This Addendum forms part of the Bid Documents and amends the Bid Documents as described below.

3. ARCHITECTURAL DETAILS - PROJECT MANUAL VOLUME 2

5. **ARCHITECTURAL DRAWINGS**

A1.1

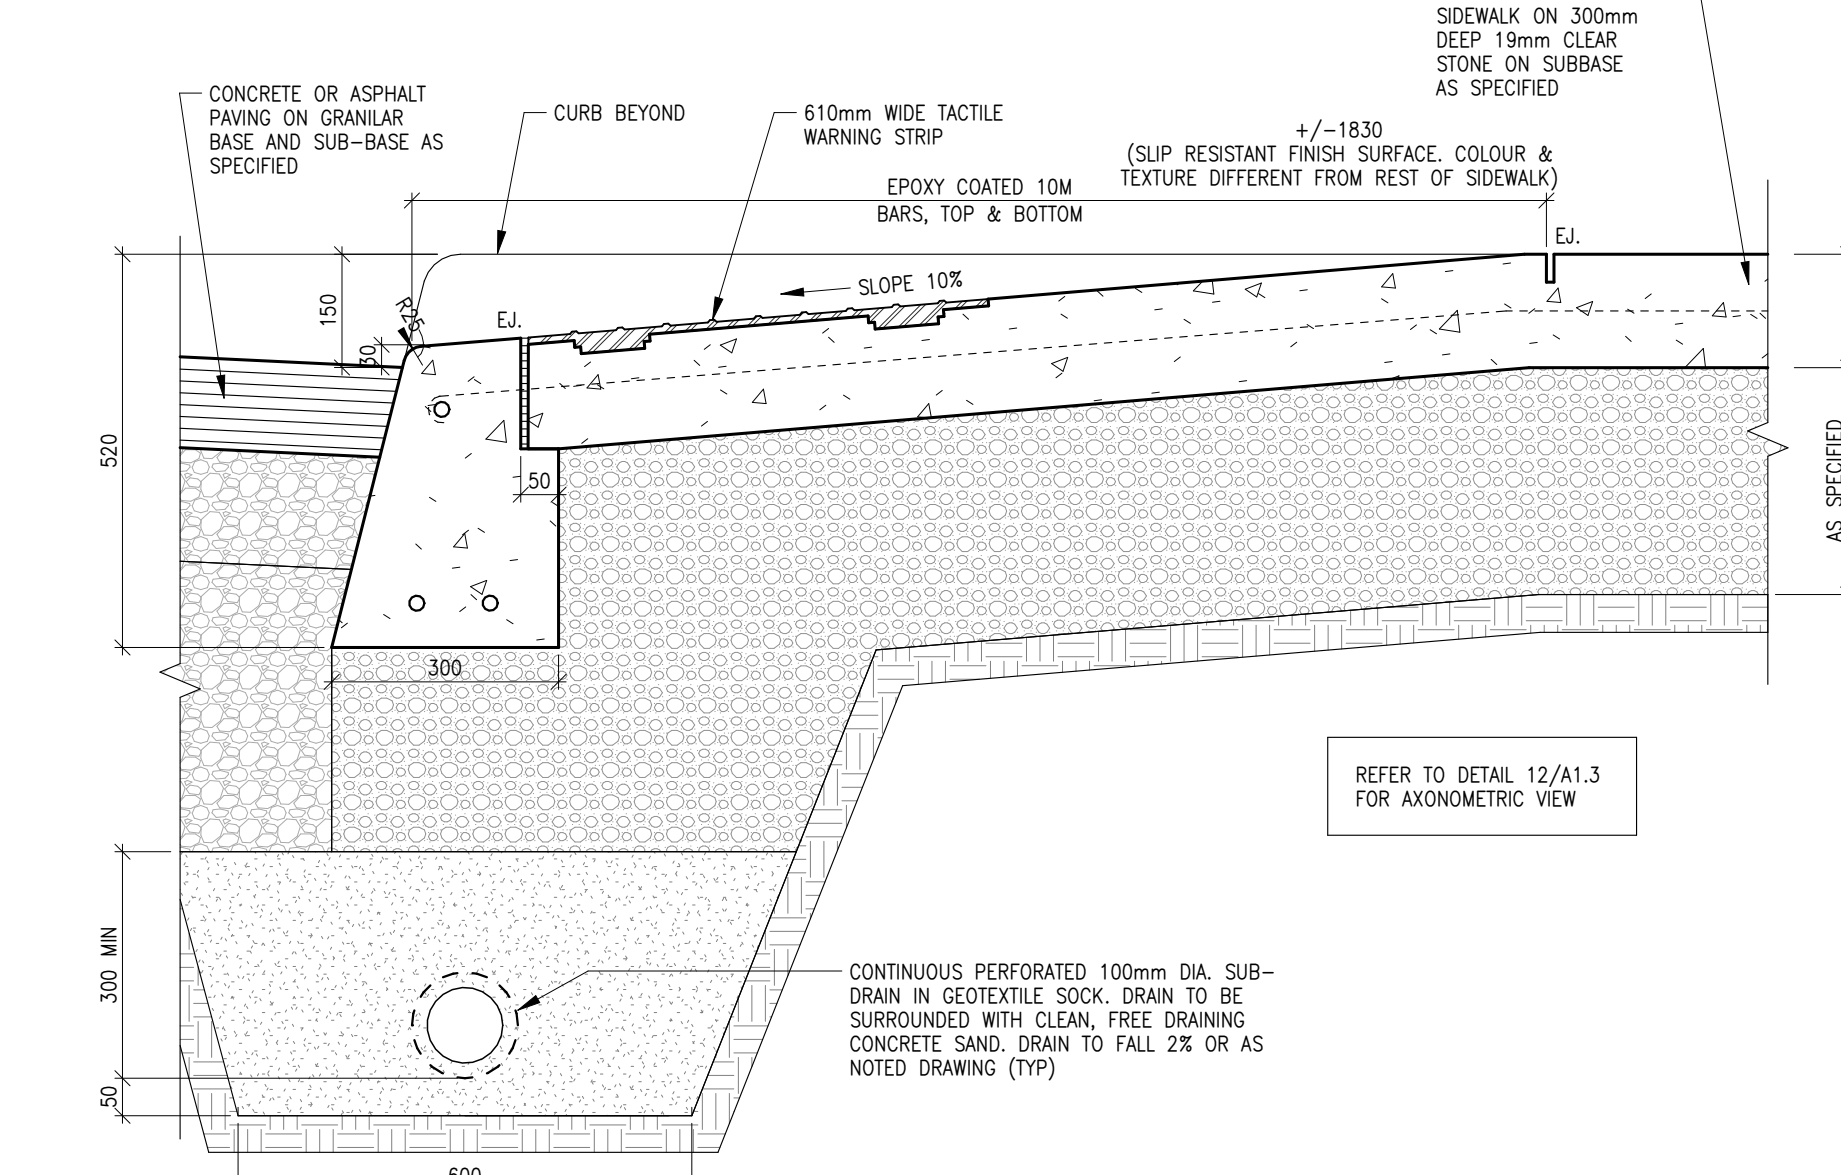
- .1 Callout for new details 31/A1.2 and 32/A1.2 added, as indicated in Sheet A1.1 issued with this Addendum.
- .2 Reference to "Below Ground Garbage Bin" replaced with "Above Ground Garbage Bin", as indicated in Sheet A1.1 issued with this Addendum.

- .1 Drawing 29/A1.2 revised from below-ground garbage bin to above-ground garbage bin, as indicated in Sheet A1.1 issued with this Addendum.

GROUND FLOOR PLAN
1:100

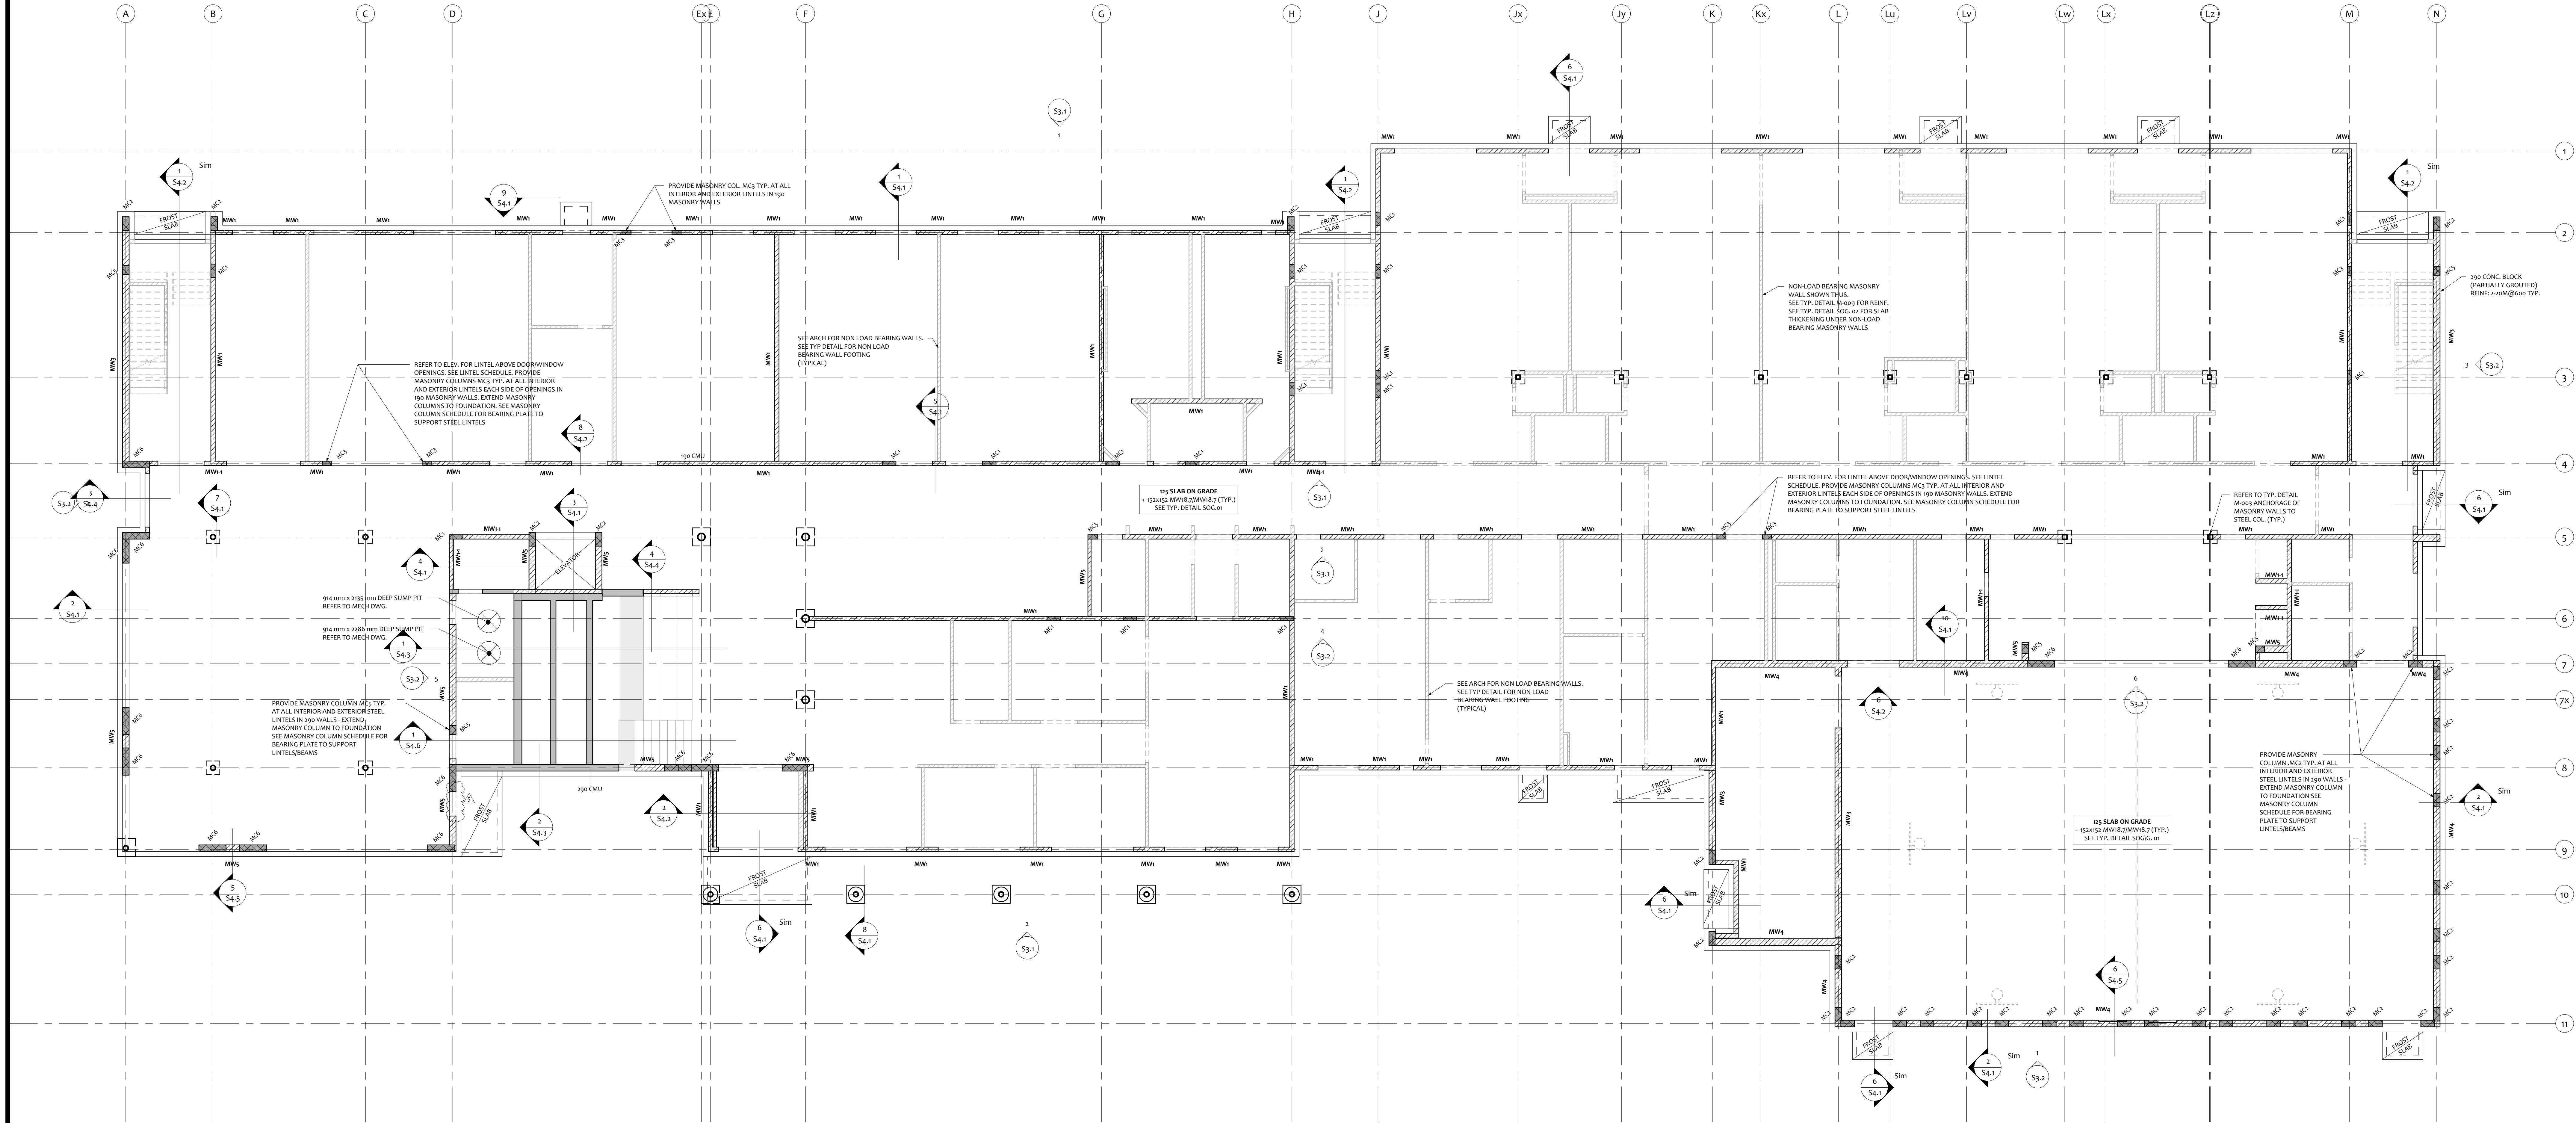
- 1.1. Drawing S2.1
 - 1.1.1. Update to USF, elevator / sump pits etc.
- 1.2. Drawing S2.2 & 2.3
 - 1.2.1. Refer to cloud for door opening and MW Lintel Requirement
- 1.3. Drawing S 4.1
 - 1.3.1. Refer to updated details 3 and 4 for revised pit depths and USF requirements.

1. Drawing E5, E6, E10 (Drawing Issued)

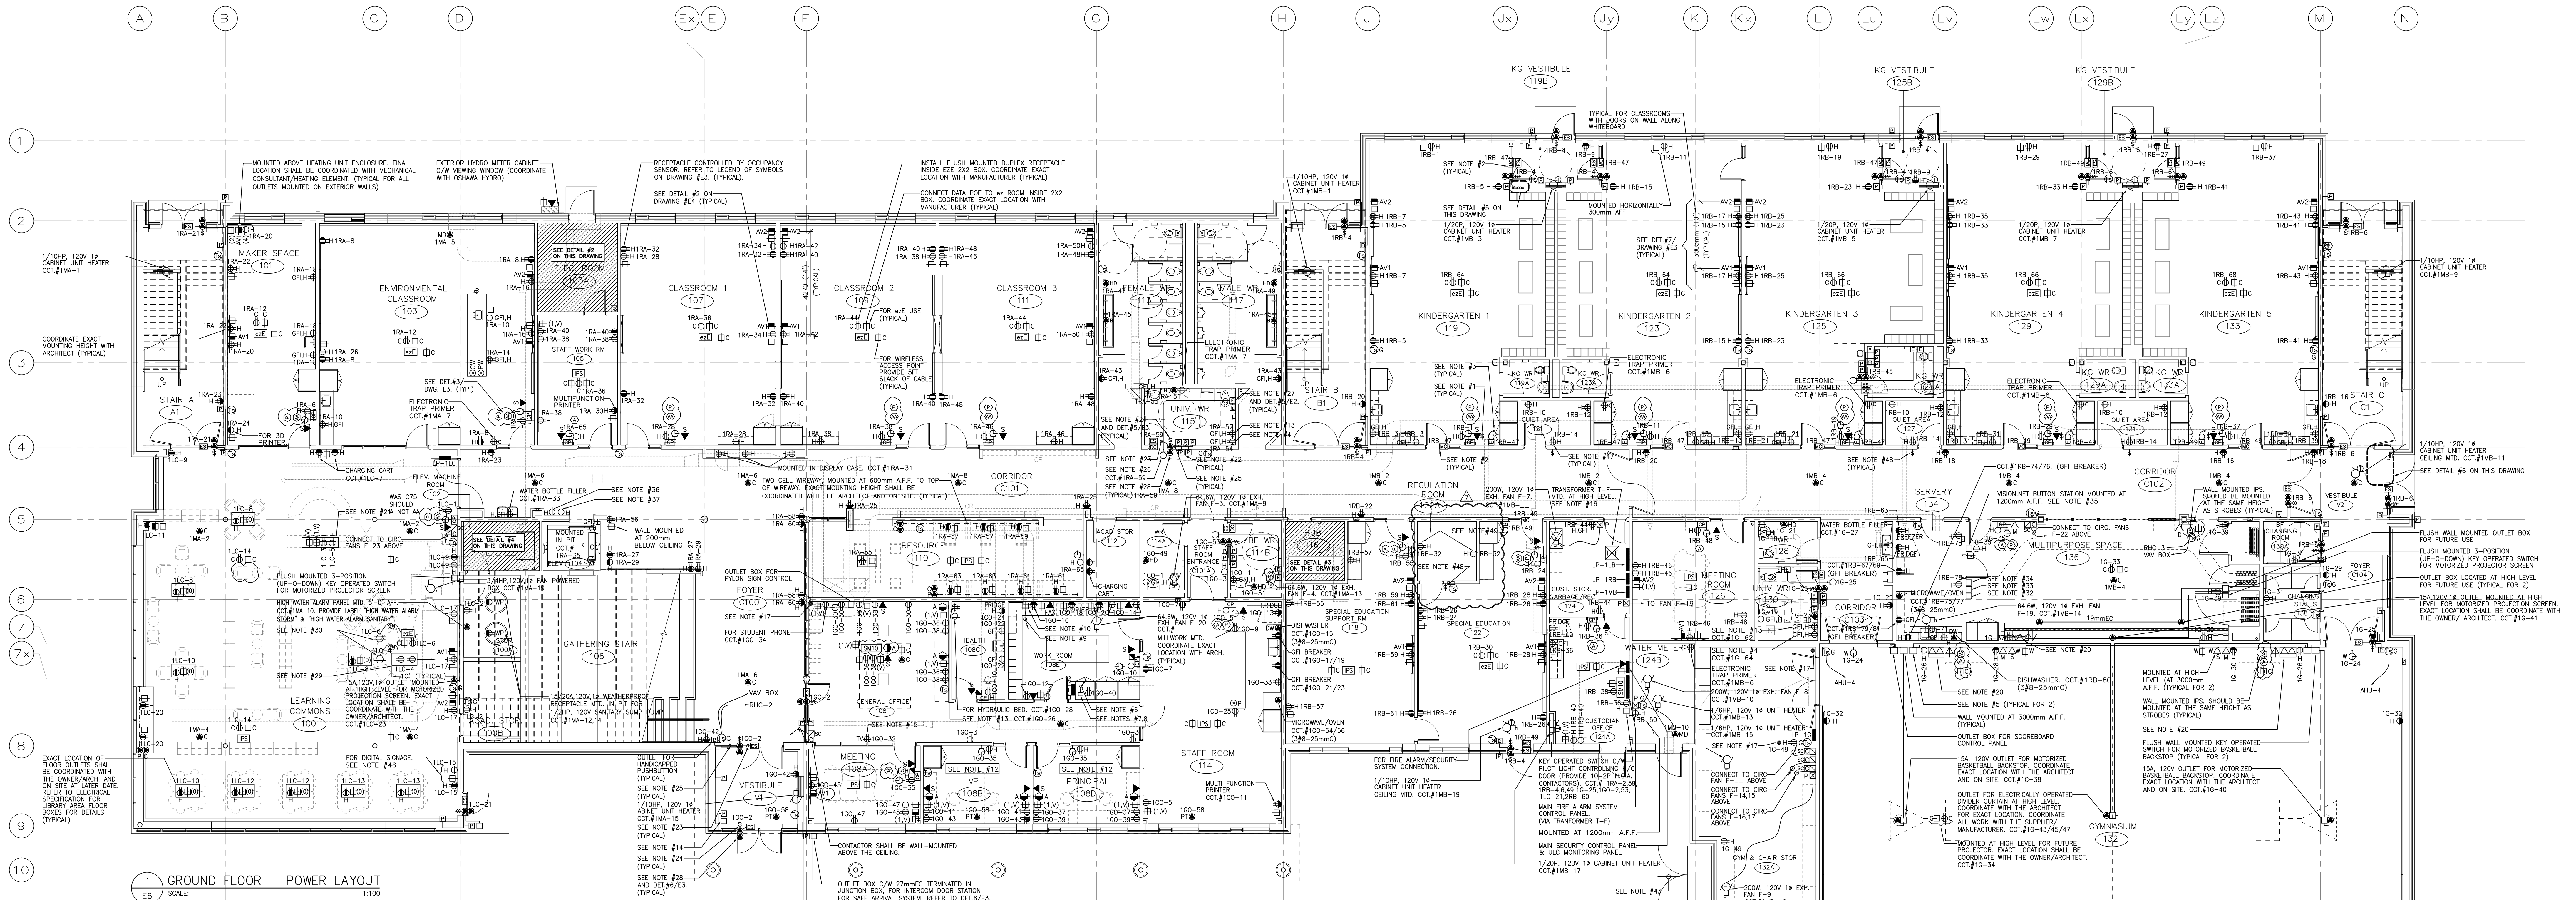
1. Ground floor Regulation Room 122A layout revised for Lighting, Power, & Fire Alarm Drawings. Refer to drawings for revised layout.
2. 15A-1P circuit 1RB-34, 1RB-52 becomes spare.
